Application for change or cancellation of resource consent condition (S.127)

8. Detailed description of the proposal:		
This application relates to the following resource consent:		
Specific conditions to which this application relates:		
Describe the proposed changes:

- 1.9. RC 2250199-RMALUC is to 'undertake earthworks, construct retaining walls and install stormwater control measures within 20m of a Scheduled Heritage Resource'. A copy of the approved resource consent and plans is attached at **Appendix 5**.
- 1.10. The table below sets out the variation to the proposed activities. The proximity of earthworks and retaining walls (buildings) within 20m of a Scheduled Heritage Resource requiring resource consent under the PDP has not changed. There is an overall reduction in the size and scale of remedial repair works being undertaken within the Hall site.

1.14. To enable the revised design, the application seeks to vary the following conditions as follows:

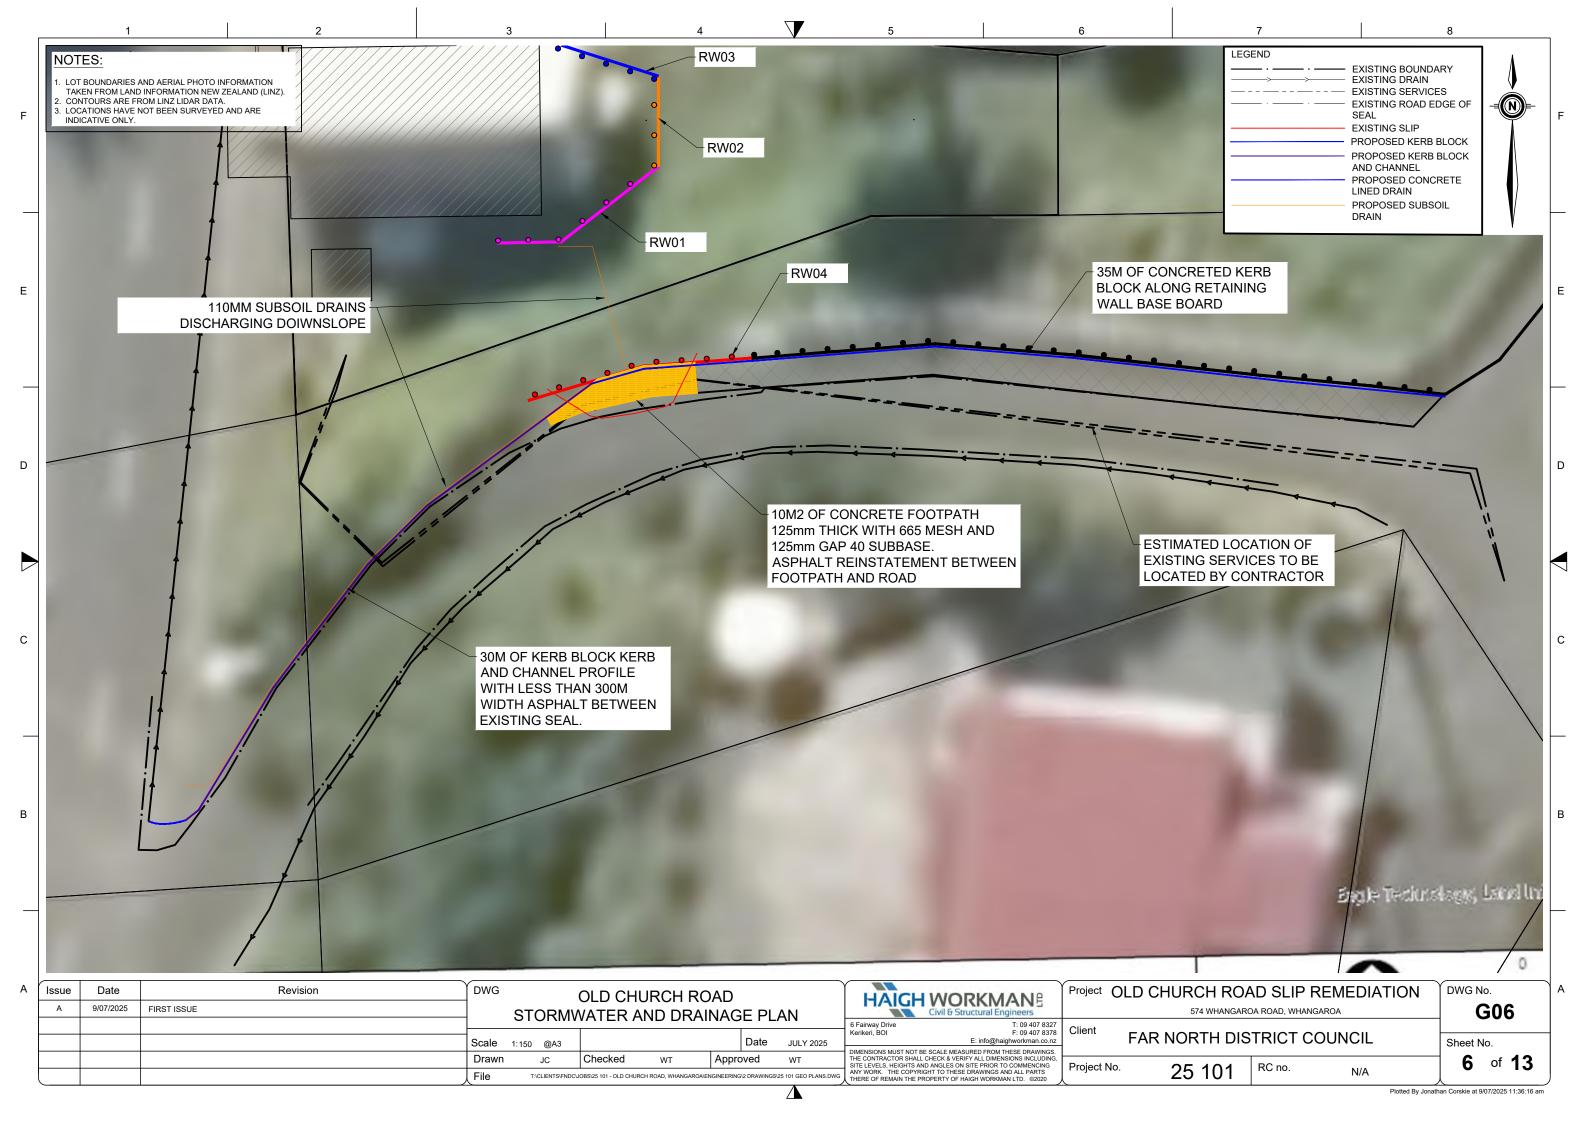
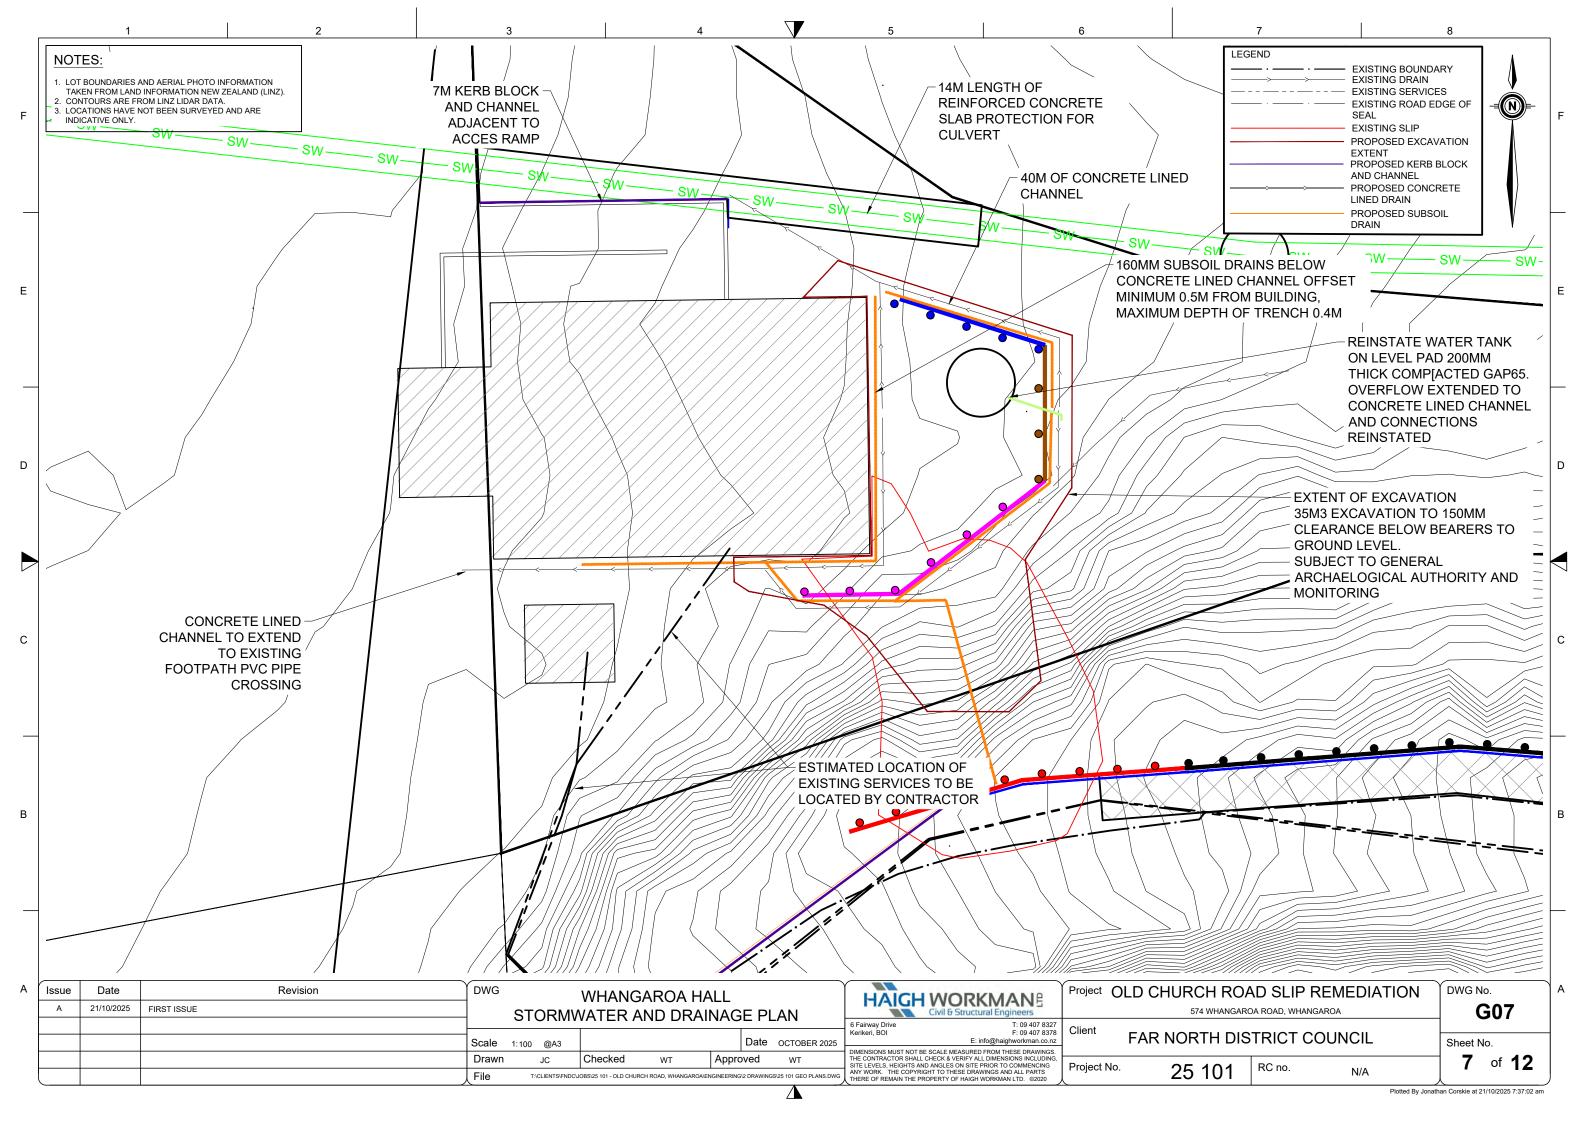
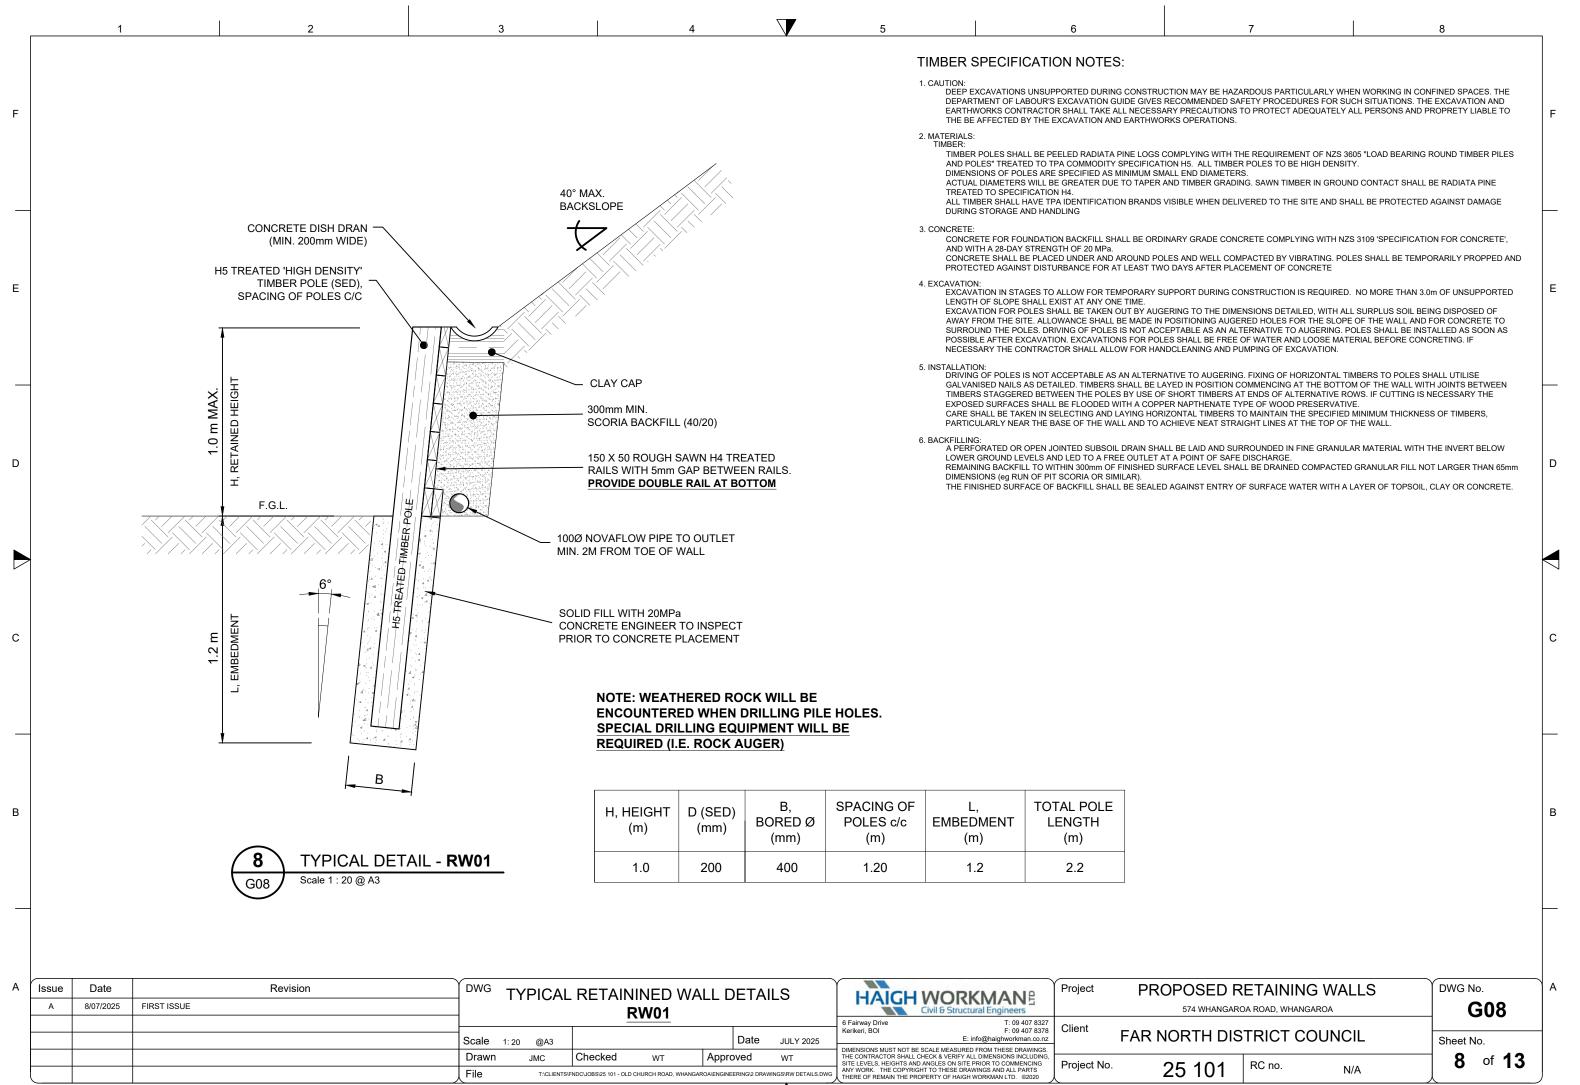
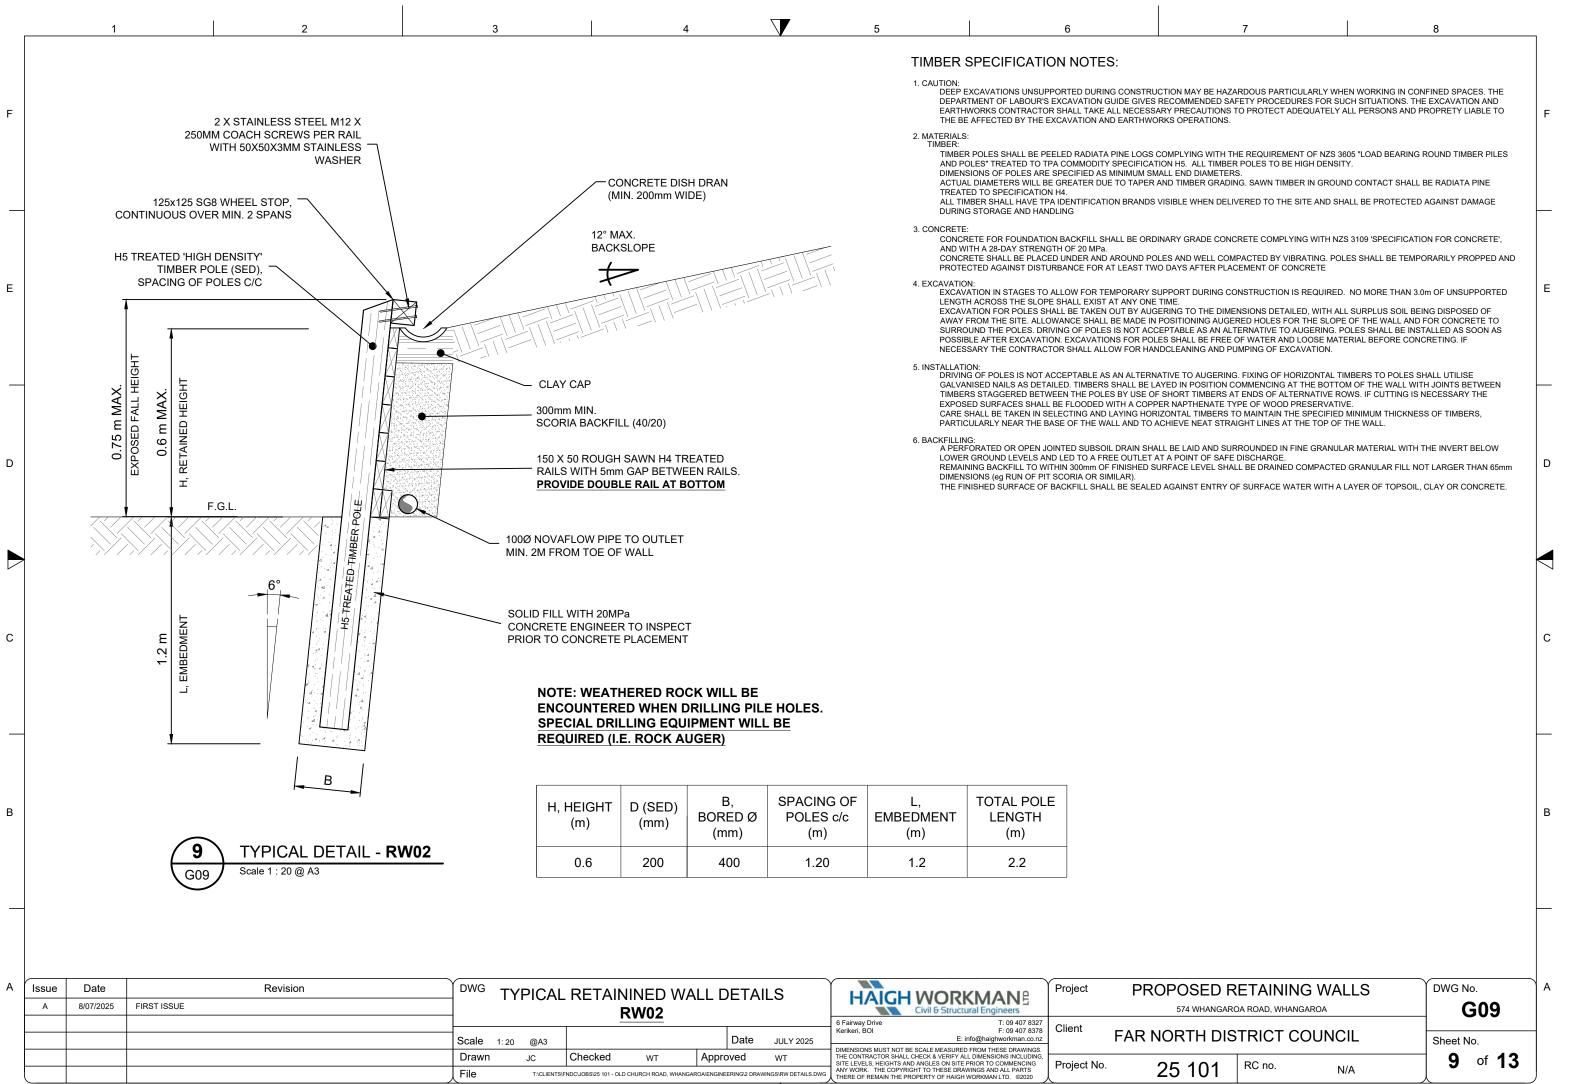
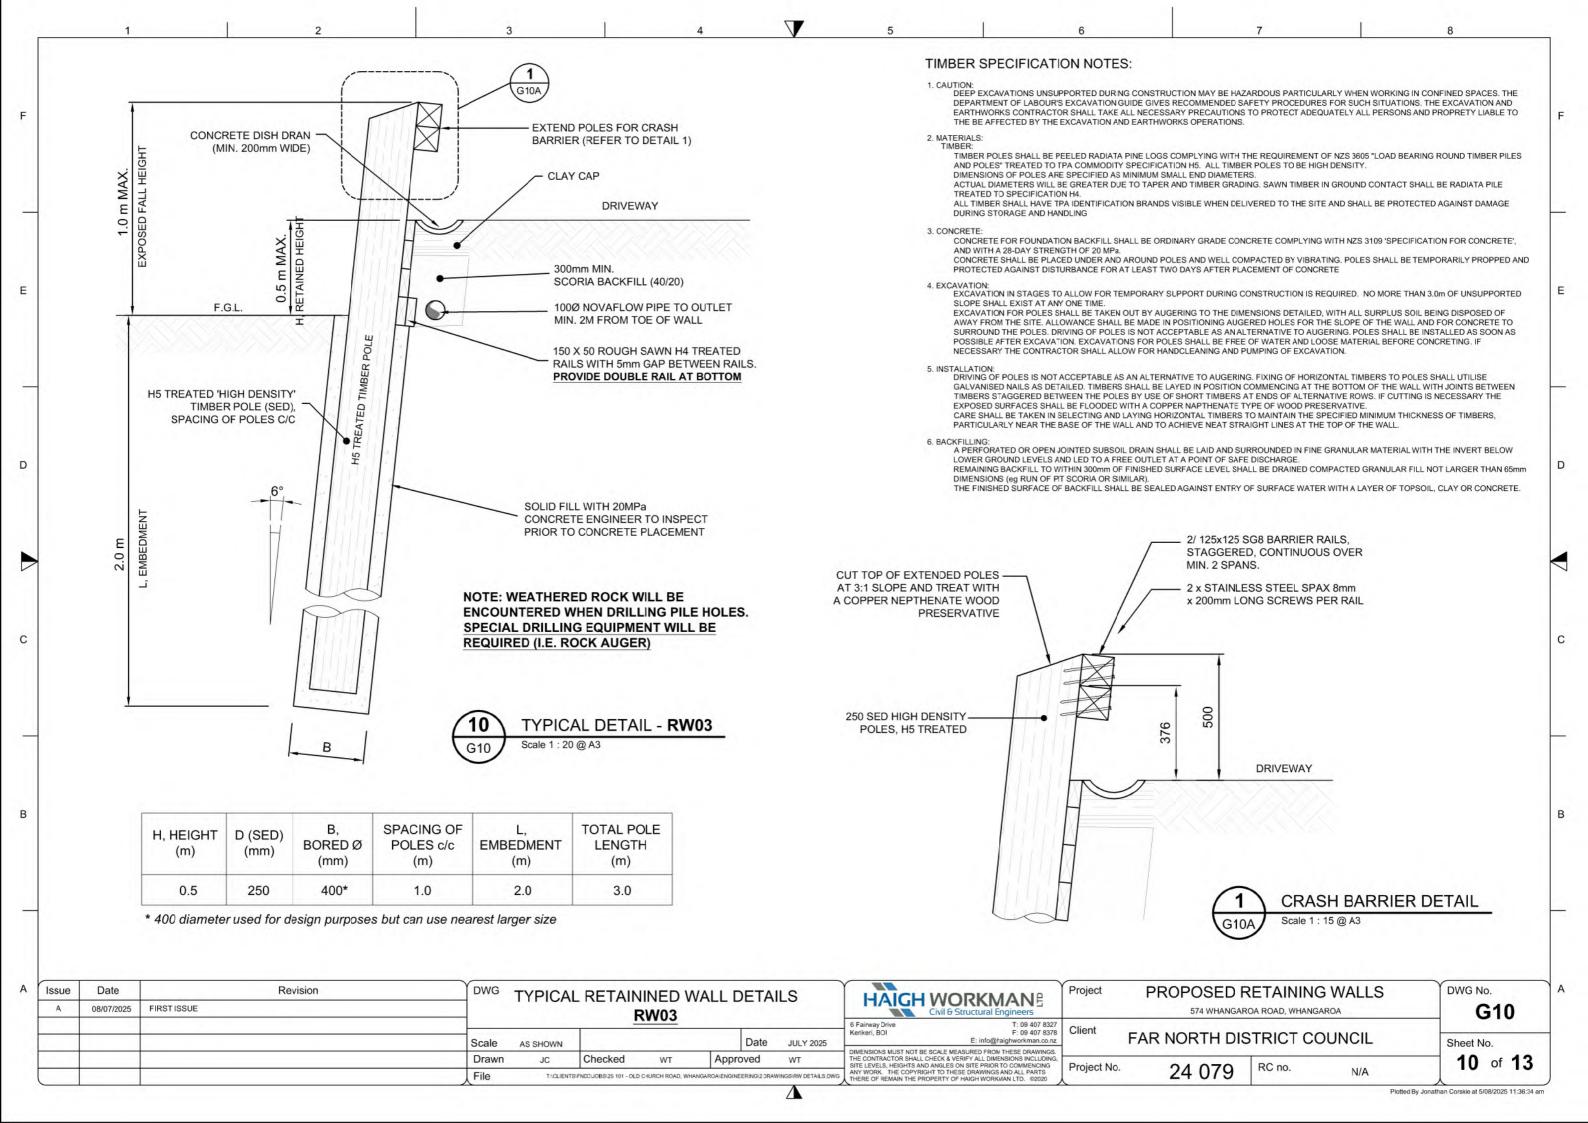
Consented Activity	Variation Proposal	
Excavation Earthworks		
Volume = 50m ³	Volume = 35m ³	
Depth = 300mm	Depth = 150mm	
Approved Plan G02	Revised Plan G03 & G07	
Retaining Walls		
RW01		
Height = 1m	Height = 1m	
Length = Not specified	Length = 7.2m	
Approved Plan(s) G01 & G04	Proposed Plan(s) G05 & G08	
RW02		
Height = 1m	Height = 0.75m

Length = Not specified	Length = 3.6m
Approved Plan(s) G01 & G05	Proposed Plan(s) G05 & G09
RWO3	
Height = 1m	Height = 0.5m
Length = Not specified	Length = 4.1m
Approved Plan(s) G01 & G06	Proposed Plan G05 & G10
Stormwater Drainage	
Dish drain above retaining wall to divert	Subsoil drains and concrete lined channel behind
stormwater entering the side in a	retaining walls to direct stormwater around
westward direction.	perimeter of the building to Whangaroa Road
	street drainage via existing stormwater culvert
	on northern side of building and concrete lined
	channel on southern side.
Approved Plan G01	Proposed Plan G07

- 1.12. As shown on the Stormwater and Drainage Plan G07, new subsoil drains and a concrete lined channel will be installed along the southern and eastern sides of the Hall building to direct stormwater westward to the kerb drainage on Whangaroa Road. On the northern side of the Hall building, stormwater from subsoil drains and a new concrete lined channel drain above the retaining wall will be conveyed to an existing FNDC stormwater culvert. The concrete lined channel will prevent overland stormwater flows from entering the Whangaroa Hall building footprint. Works involving the installation of a reinforced concrete slab required to strengthen the existing culvert will be undertaken. A new kerb block and channel will be constructed along the northern side of the Hall building adjacent to the access ramp. The proposed concrete slab protection works to the existing stormwater culvert on the northern side of the building will be undertaken adjacent to an identified HAIL site that is a former petrol station.

Condition 1 – The activity shall be carried out in general accordance with the approved plans prepared by Haigh Workman Ltd, referenced 24 079 25 101, dated 'May 2024, and attached to this consent with the Council's "Approved Stamp" affixed to them.

NB: The revised plans to be included in the approved plan set are set out in paragraph 1.4 above. There are various plan dates so suggest these are listed in the consent condition 1.
